NUCLEAR REGULATORY COMMISSION

Title: Advisory Committee on Reactor Safeguards Materials, Metallurgy and Reactor Fuels

Date: Wednesday, September 21, 2011

Base Case Results

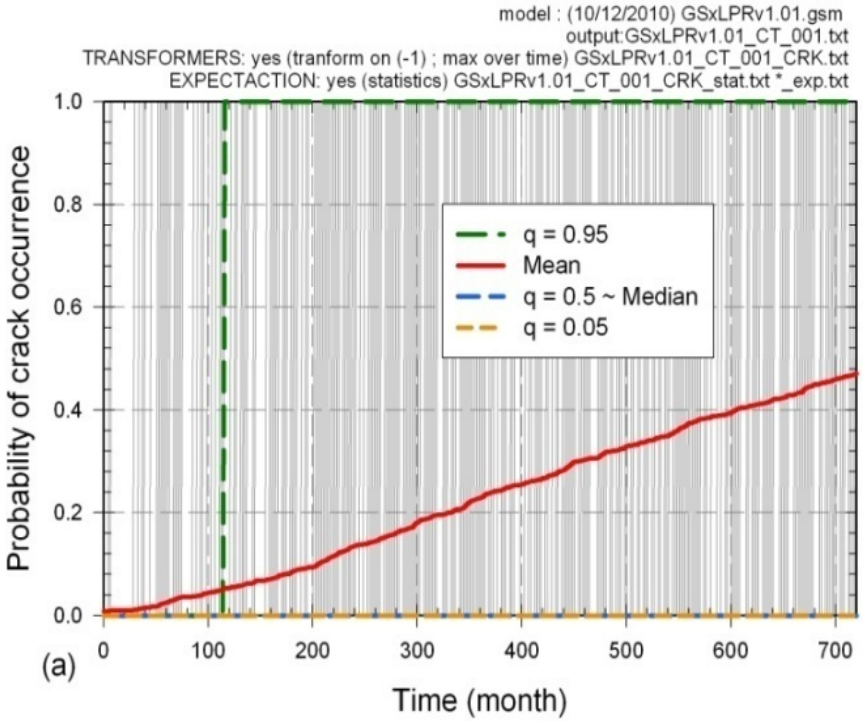
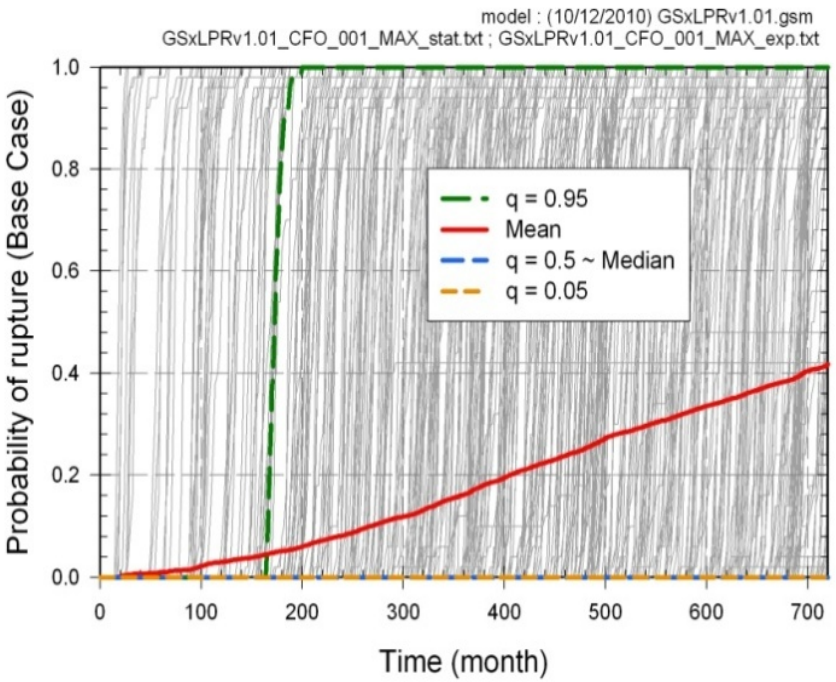
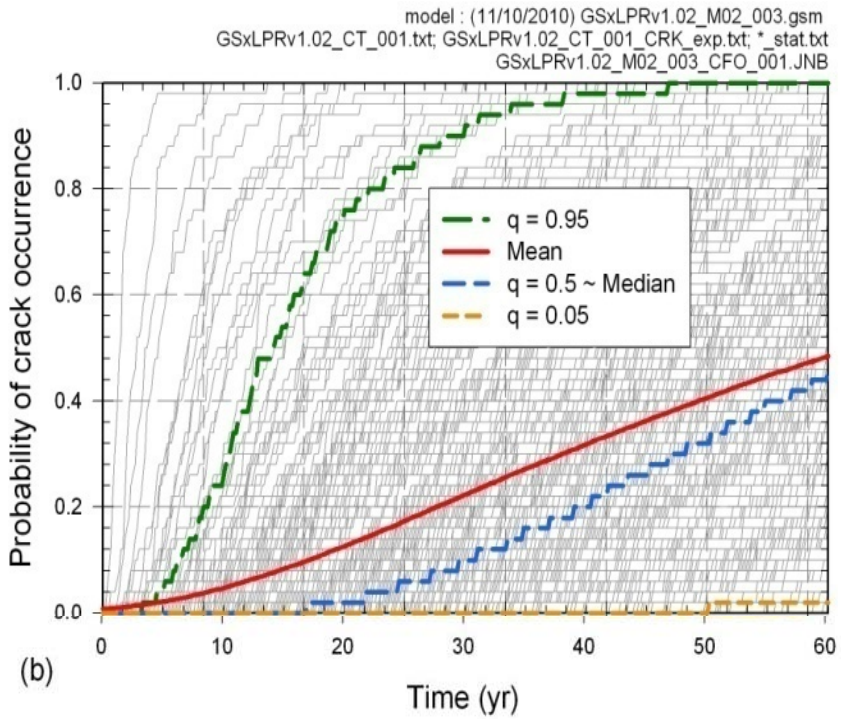
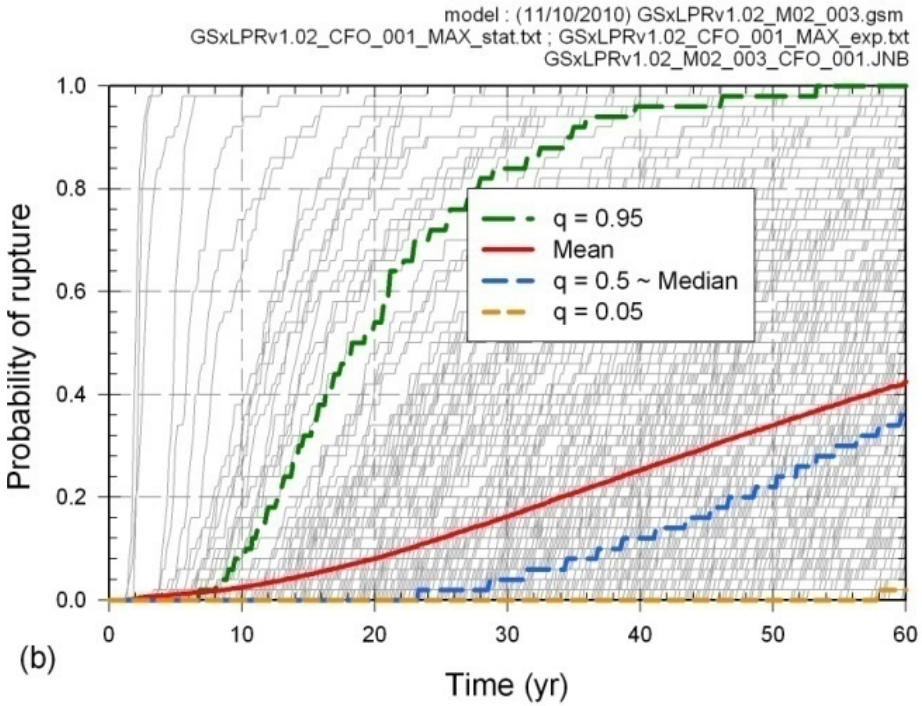
MEMBER STETKAR: Okay, now why? if you're actually carrying through all of the distributions, and you have a full sampling of all of the distributions, why this dramatic change just because you throw one parameter into one bin versus another?

MEMBER STETKAR: I guess maybe I'm not phrasing my question--

MR. RUDLAND: What we did in the first case though, we just forced everything to be epistemic. So it's saying that for an epistemic realization on crack initiation, there's no variability, is basically what's it's saying. That's why you get either zero or one; it either happens or it doesn't; there's no variability. Where when it's aleatory, now there is variability per epistemic realization, so you see that now there's curves on the gray lines for each of those different realizations. And again, it doesn't change the mean value because

Other Results

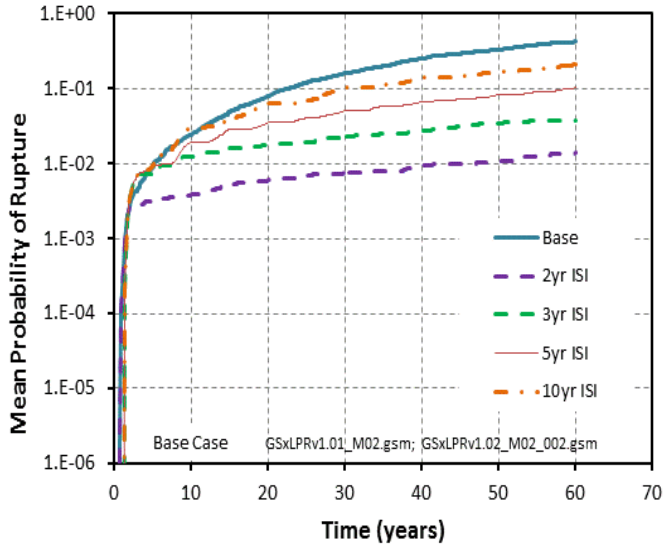
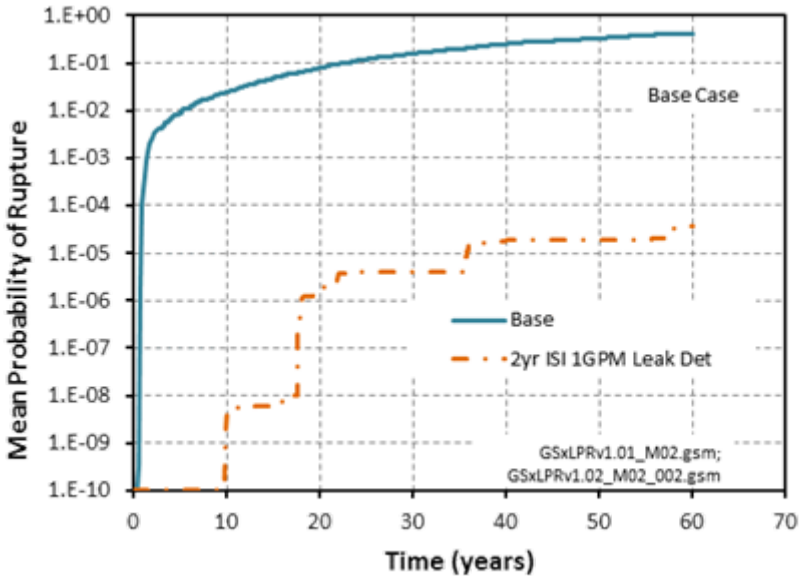
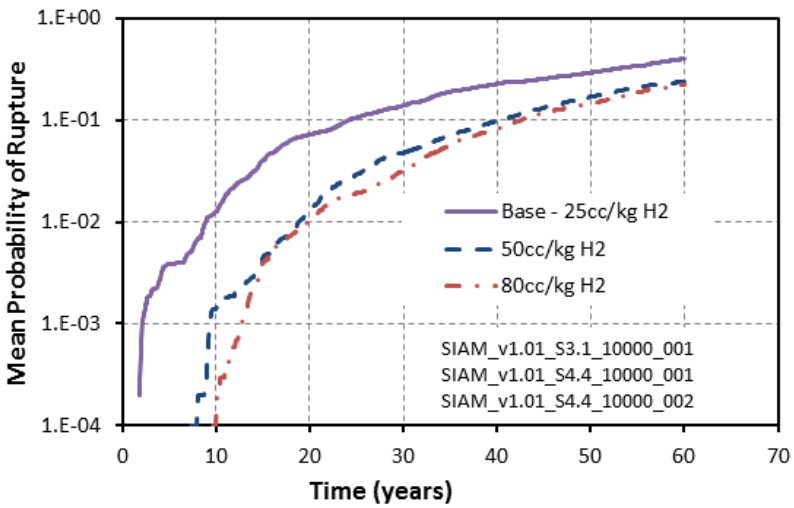
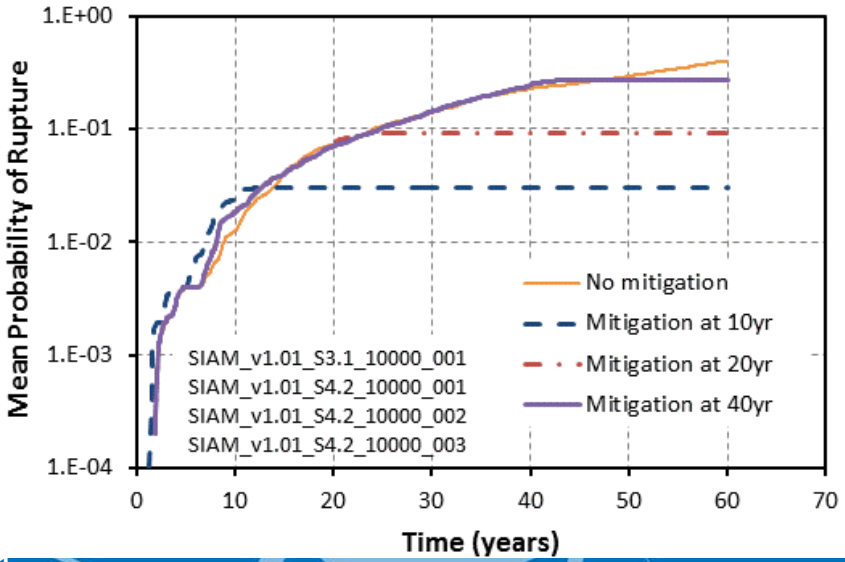
MEMBER STETKAR: You know, I read through these results, and I looked at--I tried to understand them, and I understand why the inspection, you know, in principle gives you what those results show on the upper left hand corner. I also understand why the leak detection doesn't give you an awful lot, because of the size of the leak. In fact, the inspection if I look at a two-year inspection interval, it's roughly a factor of 25, let's say, and the leak detection at a 1 gpm leak detection gives you a factor of, I'm going to say 10; it's a little less than 10. If I

combine those two now, suddenly I get 25 from one, 10 from another, and somehow they combine to 10,000. That to me--and it's explained--there's explanatory text in your report about leak detection individually, about inspection individually; the sole explanation for the upper right hand corner is "the effective combination of leak detection and inspection and the base case mean probability of rupture is shown figure 28. These results illustrate almost a full order of magnitude decrease in the probability of rupture." Why? You know, what's going on in the model that results in such an extensive compound effect from those two things that are not individually--

MEMBER STETKAR: --over time, both detection and inspection give you such a dramatic change, that everything else being held equal, I would have estimated a factor of maybe a few hundred, maybe a thousand, because I understand there's compound effects. But 10,000 is a pretty large number, or small number, depending on which way you're going.

MEMBER STETKAR: Well, they seem to--I'd just like a better explanation in laymen's terms, because as I said, I sort of understood individually why. It was a bit surprising, but when I thought about it, I understood individually why they were not as effective as I would have expected them to be, but then I was surprised that the composite effect was so much more effective than I would have expected to be, given the individual contributors. So if there's a reasonably--a reasonable explanation for that, it would be appreciated, because--

tenth of a--a margin of 1.1 to go through, you don't have as much time to remove it as you do one that has a margin of 10 on crack size or something like that. So I think it's a combination of those--it's finding those particular cases where you have a very long crack--
